Service Bulletin

S.B. No: 82

Title: INSPECTION OF WING WALKWAY AREAS

CHANGES INCORPORATED BY THIS ISSUE 3

FIGURE 1 STBD (RH) DRN – PORT (LH) SIMILAR

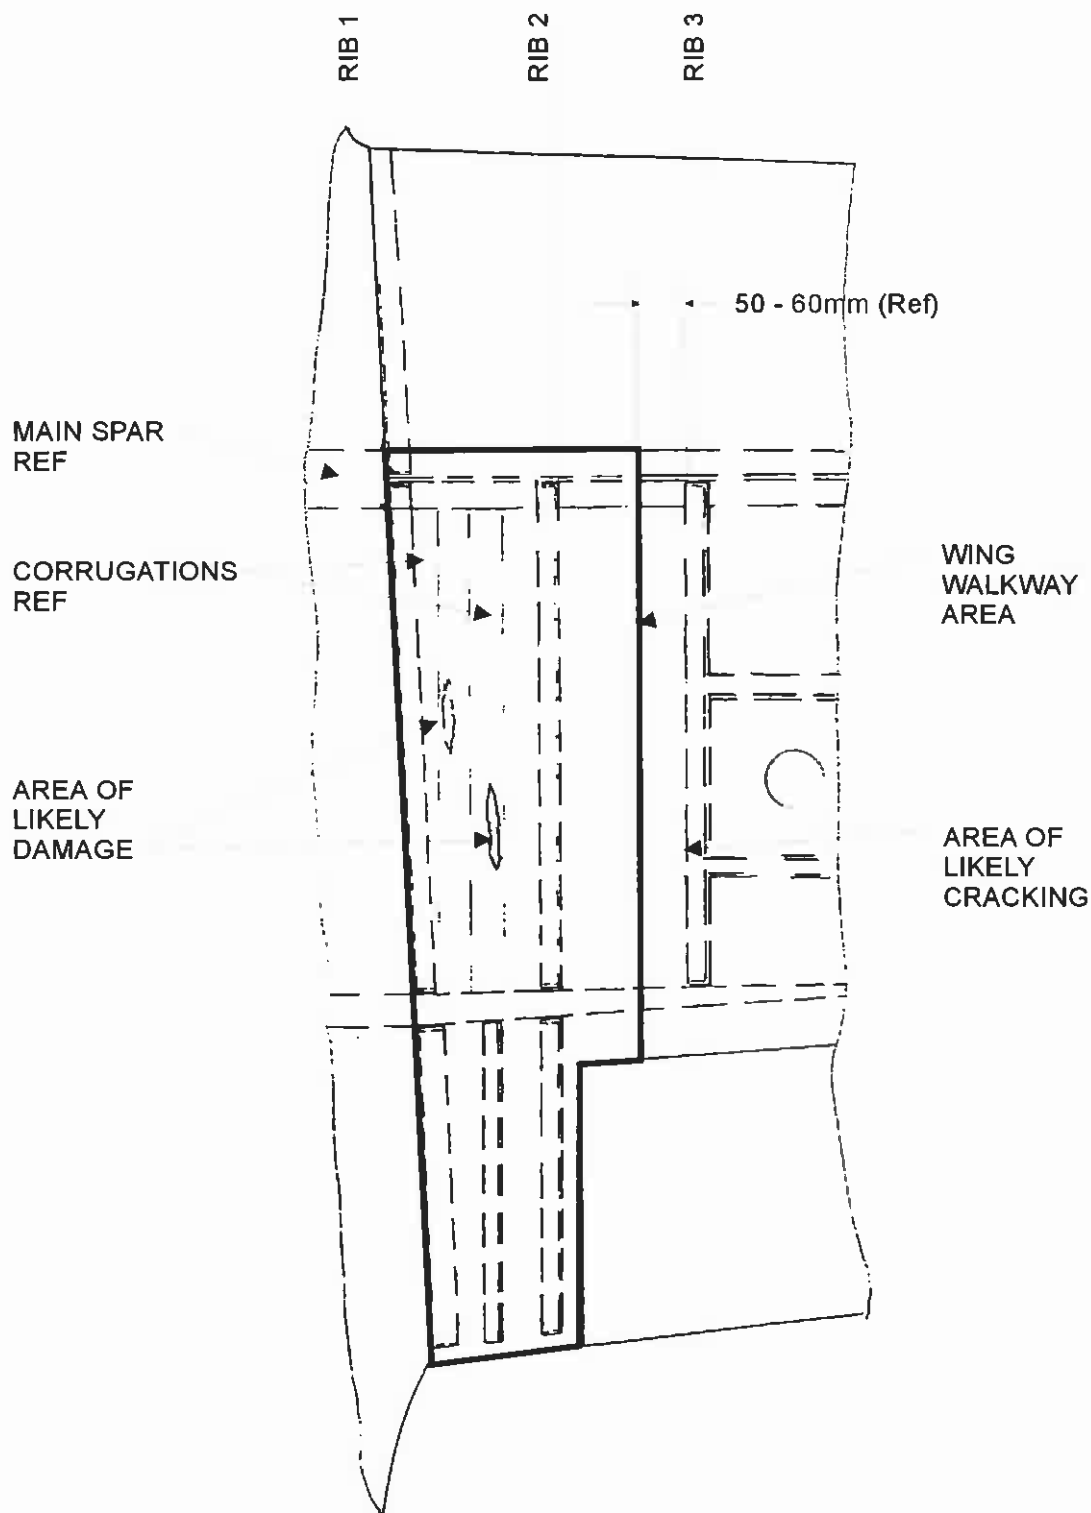
Issue 3 Compliance revised, references to cracking inboard of Rib 3 added, Mod. M827 and repair scheme, T67G-03-075, added. Applicability reference T67M260 was works no 2234 and 2235 now "prior to works etc. Modification's Definitions Table 1 and Action Matrix added. Paragraphs 2 and 3 re-written to reflect Actions Matrix. Figure 1 amended to show area of Rib 3 cracking.

Two cases have been reported of delamination in the skin and corrugations in the area of the wing walkway. Reference Figure 1.

Subsequent to Issue 2, cracking inboard of Rib 3 flanges has been reported.

1. At next 150 (or 100 for US registered aircraft) flying hour check, reference Figure 1:
 - i. Visually inspect wing walkway area by either viewing through flap drive access hole in undersurface of wing or through Rib 1 (seats out). Also press down over wing walkway area: there should be no signs of delamination on corrugation or "spongy" feel to walkway.
 - ii. Inspect for cracking in region of Rib 3, by pressing down slightly inboard of the rib and noting any relative movement of skin.
2. If the wing is not damaged, refer to Action Matrix Reference # 1.
 - ii. If the fluid lines are leaking at the clamp positions, replace.
 - iii. If the fluid lines feel soft when squeezed, replace.

- iv. If the fluid lines do not appear to have a yellow cast, replace.
- v. If in doubt, replace.
3. If the wing walkway area is found to be suspect or has damage, remove wing walk tape and surface finish to ascertain degree of damage. Wing walkway tape is to be carefully removed by removing wing seal, lifting corner of wing walk tape and pulling back applying gentle heat at the base of the lifted tape. Ensure the heat source is not stationary at any one point.
4. If there is damage to the wing walk way skin or corrugation refer to Action Matrix References # 2 – 5 and 8 for action to be taken.
5. If there is damage/cracks at Rib 3 then refer to Action Matrix References 6 – 8 for action to be taken.
